RUTH M. HAVEY · *Landscape Architect* ☼ TWENTY-FIVE FIFTH AVENUE · NEW YORK 3, N.Y.

DUMBARTON OAKS AGENDA---August 2, 1949

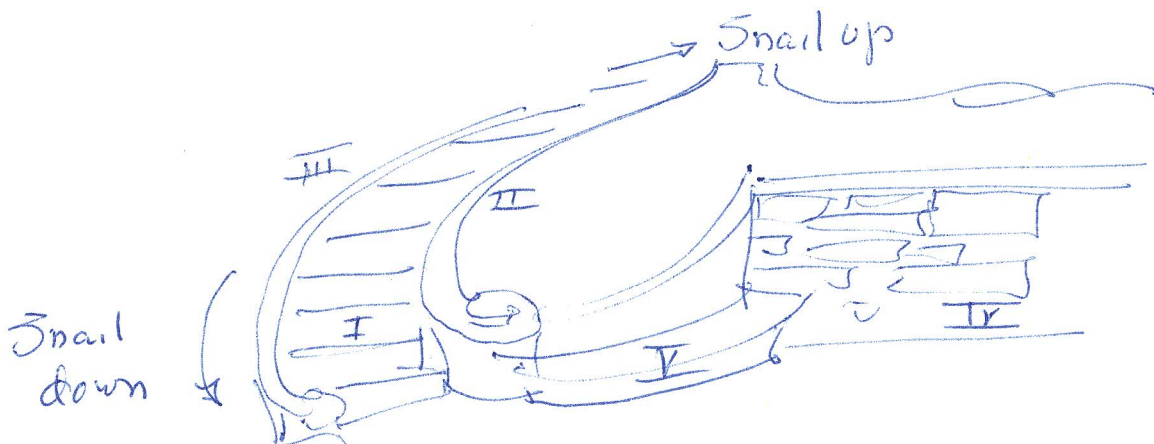
Sketch plan of concrete paving for the arbor garden.

Pebble concrete center

Smooth concrete scrolls

Beds of lavender at corners.

Sundial at center

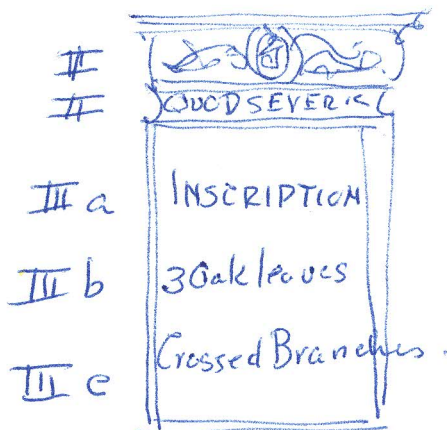
I---Shield and Arms executed in lead---

Oak leaves cast in lead---Make mould in place before removing.

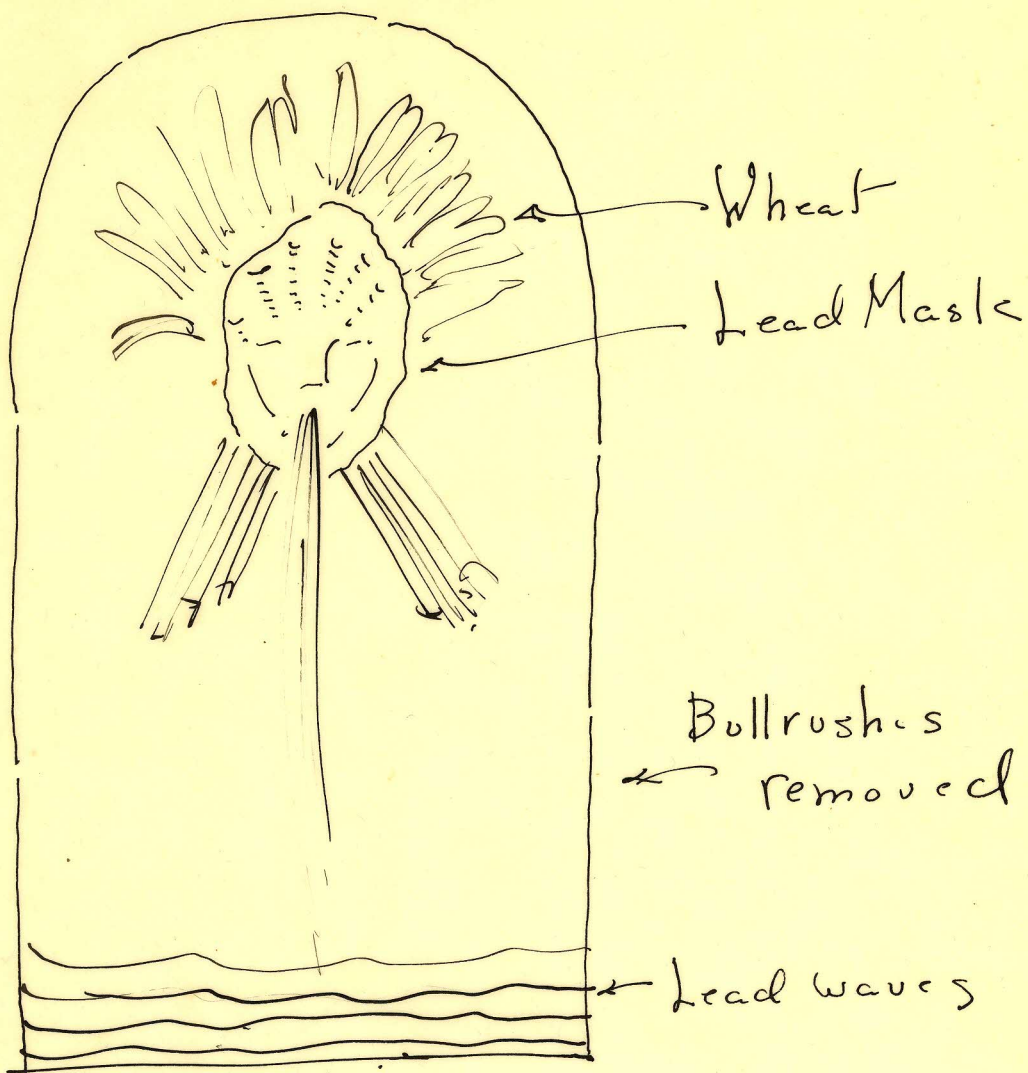
Consider the conversion of the cold greenhouse to a Garden Center

Glass roof replaced with:
lead covered copper?
slate?

New Floor

Mr. Steinbraker to send plan of existing building and rough estimates of the probable cost of ~~replacing~~ the roof and ~~altering~~ the ~~heating system~~---new floor.~~---new cold frames.~~

PANEL ON WALL IN ARBOR
without Bullrushes

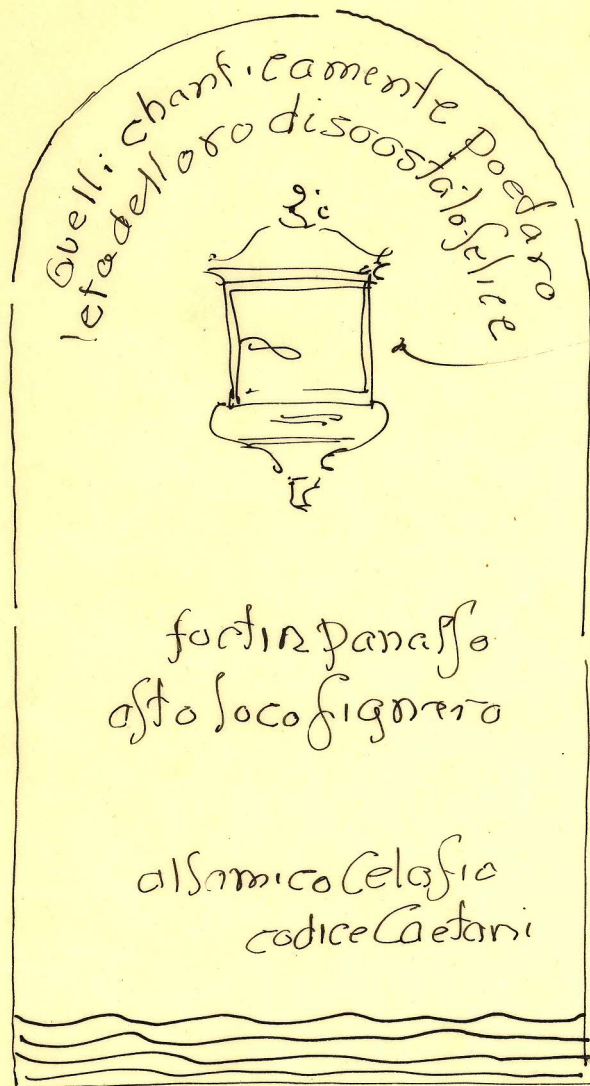
Sketch two panels in arbor wall without lead lotus and
bullrushes---leave waves.
